COUNCIL SUPPLEMENTARY ASSESSMENT REPORT

SYDNEY EASTERN CITY PLANNING PANEL

PANEL REFERENCE & DA NUMBER	PPSSEC-337 – DA-2024/205
PROPOSAL	BATA 2 - Lot F – Removal of trees, excavation, and construction of three (3) connected buildings of 6-13 storeys comprising two (2) levels of basement car parking, 224 residential units, communal recreational facilities, associated landscaping, and construction of a private road.
ADDRESS	16 Studio Drive Eastgardens (Lot 34 DP 1312041)
APPLICANT	Karimbla Properties (no.39) Pty Ltd
OWNER	Karimbla Properties (no.39) Pty Ltd
DA LODGEMENT DATE	28/08/2024
APPLICATION TYPE	General Development
REGIONALLY SIGNIFICANT CRITERIA	CIV >\$30 million
CIV	\$132,785,999
CLAUSE 4.6 REQUESTS	FSR – 2.97:1
LIST OF ALL RELEVANT PLANNING CONTROLS (S4.15(1)(A) OF EP&A ACT)	<ul style="list-style-type: none"> • <i>State Environmental Planning Policy (Planning Systems) 2021</i> • <i>State Environmental Planning Policy (Sustainable Buildings) 2022</i> • <i>State Environmental Planning Policy (Housing) 2021</i> • <i>State Environmental Planning Policy (Biodiversity and Conservation) 2021</i> • <i>State Environmental Planning Policy (Resilience & Hazards) 2021</i> • <i>State

MIDWINTER SHADOW IMPACT - LOT J and H (Town Houses) ONTO LOT F	
9.00am	
12.00pm

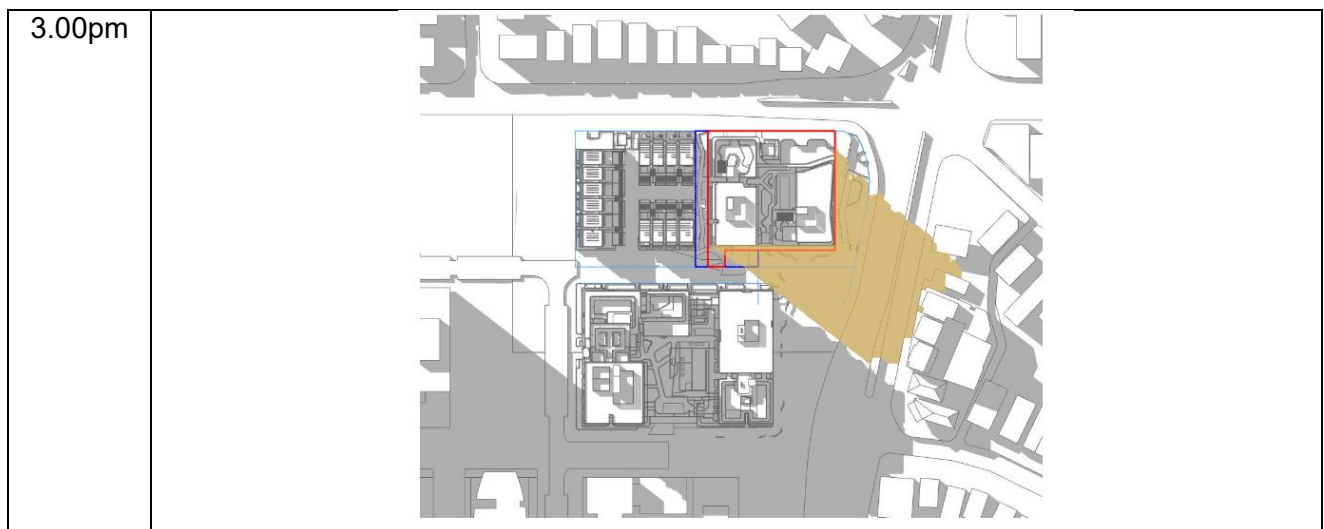
The midwinter shadows cast by the proposed building upon Lot J and H onto the proposed building upon Lot F are identified below.

Level	Total Units	Total Units Impacted by LOT J and H	Units Impacted by LOT J and H that receive 2hrs sun	TEST <i>1m² above 1m for 15min</i>	Compliance <i>2Hrs Sun</i>
Ground	17	5	4	Y	11
Level 1	22	5	5	Y	14
Level 2	26	6	5	Y	17
Level 3	26	4	4	Y	18
Level 4	26	3	3	Y	20
Level 5	26				21
Level 6	22				18
Level 7	15				11
Level 8	11				9
Level 9	11				9
Level 10	6				6
Level 11	6				6
Level 12	6				6
Level 13	4				4
Total	224	23	21	21/21	170
				100%	75.9%

- A total of 23 of 244 units (9.4%) within Lot F from ground level to level 4, are impacted by overshadowing from the proposed redevelopment of Lot J and H to some extent.
- Of the 23 affected units, analysis concluded that 21 of the 23 retain 2 hours solar access in midwinter with 1sq/m of direct sunlight, measured 1 metre above floor level, for 15 minutes into the living room and private open space in midwinter at varying times of the day.

- Overall, 170 of 224 (75%) units in Lot F retain 2 hours solar with 1sq/m of direct sunlight, measured 1 metre above floor level, for 15 minutes into the living room and private open space in midwinter at varying times of the day.
- Overall, 20 of 224 (8.9%) receive nil solar access, 15% (33.6) are permitted to receive nil solar access as per ADG.
- Overall, 35 of 224 (15.6%) receive less than 2 hours of solar access in midwinter.

Based on the above, the proposed redevelopment of Lot J and H is not expected to diminish solar access to proposed units within the Lot F building, below the minimum requirements of the Apartment Design Guide.

The proposal complies with Part 4A – Solar and Daylight Access of the Apartment Design Guide.
